HISTORIC AND DESIGN REVIEW COMMISSION

HDRC CASE NO: 2022-511
ADDRESS: 410 LEIGH ST
LEGAL DESCRIPTION: NCB 725 BLK 7 LOT 3
ZONING: R-6, H
CITY COUNCIL DIST.: 1
DISTRICT: Lavaca Historic District
APPLICANT: jennifer young
OWNER: BEACH CHRISTOPHER GRAHAM & YOUNG JENNIFER ROSALIND
TYPE OF WORK: Installation of front yard fencing, walkway replacement, installation of a front porch screen
APPLICATION RECEIVED: October 03, 2022
60-DAY REVIEW: Not applicable due to City Council Emergency Orders
CASE MANAGER: Edward Hall

2022.10.03
HDRC SUBMISSION
410 LEIGH STREET
SAN ANTONIO, TX
78210

SITE PLAN - FENCE PERIMETER - 410 LEIGH STREET

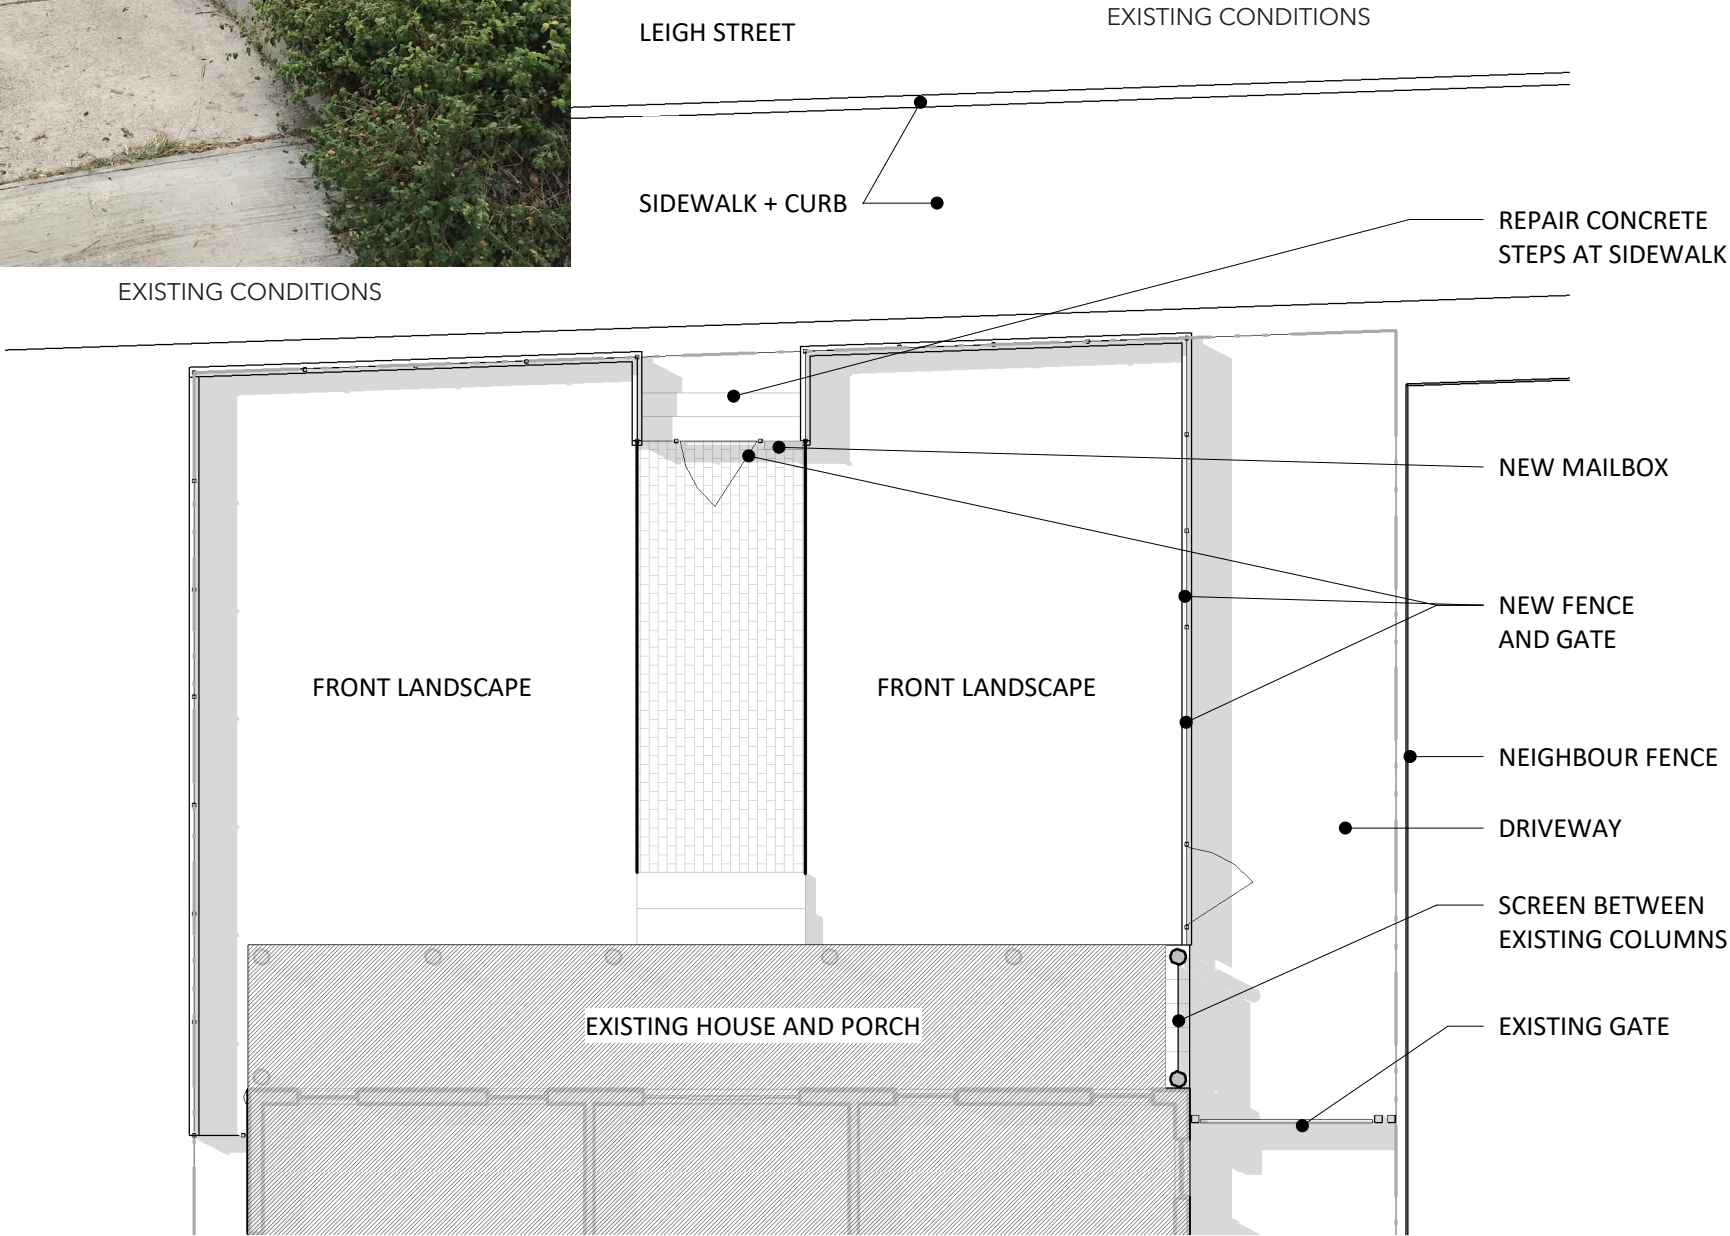
- c. FENCING – The applicant has proposed to install a front yard fence to feature metal and wire panel construction. Per the applicant, the fence will not exceed four (4) feet in height. The proposed fence will enclose the front yard and will feature two gates. Staff finds the proposed fence to be appropriate and consistent with the Guidelines, as its design is consistent with those found within the district and on this block.

- d. WALKWAY REPLACEMENT – The applicant has proposed to replace the existing, concrete walkway with a brick walkway. Per the Guidelines for Site Elements 5.A.iii., new walkways should follow the alignment, configuration, and width of walkways found historically within the district. Walkways on Leigh Street feature both brick and concrete paving. Generally, staff finds the replacement of the existing walkway with a brick walkway to be appropriate.

- e. SCREENING ELEMENT – The applicant has proposed to install a screening element between the existing wall column and front corner column on the east façade. The Guidelines for Exterior Maintenance and Alterations 7.B.i. notes that front porches should not be enclosed; however, screening panels should be simple in design as to not change the character of the structure or historic fabric. Generally, staff finds the installation of a screen to be appropriate; however, the screen should be simple in nature, should not obscure the opened porch form, and should not feature dark screening elements. Final specifications are to be submitted to OHP staff for review and approval.

1. Staff recommends approval of item #1, front yard fence installation as submitted based on finding c.
2. Staff recommends approval of item #2, front walkway replacement based on finding d with the stipulation that the existing walkway width be maintained. Final brick color is to be submitted to OHP staff for review and approval.
3. Staff recommends approval of item #3, the installation of a porch screening element based on finding 3 with the following stipulations:
 - i. That the screen should be simple in nature, freestanding (not attached to porch), should not obscure the opened porch form, and should not feature dark screening elements. Final specifications are to be submitted to OHP staff for review and approval.
